Title: BEKO gas cooker product range modification

SAFETY ALERT 015

BEKO Plc Installation/modification Instructions

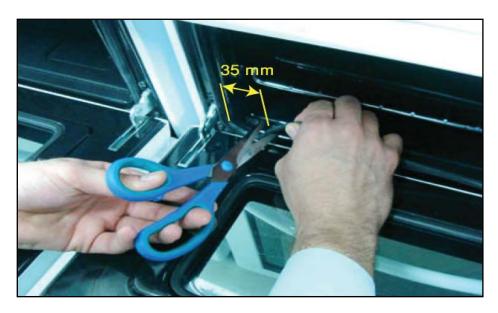
It is important that during installation of this product that you carry out the following modification to the Grill door seal **prior** to installation.

Pull the bottom of the seal away from the cooker without removing the hooks from the hole and cut the seal 35mm in from the hook on both the bottom left hand and right hand corners of the seal as shown in the picture below and remove the bottom piece of the seal.
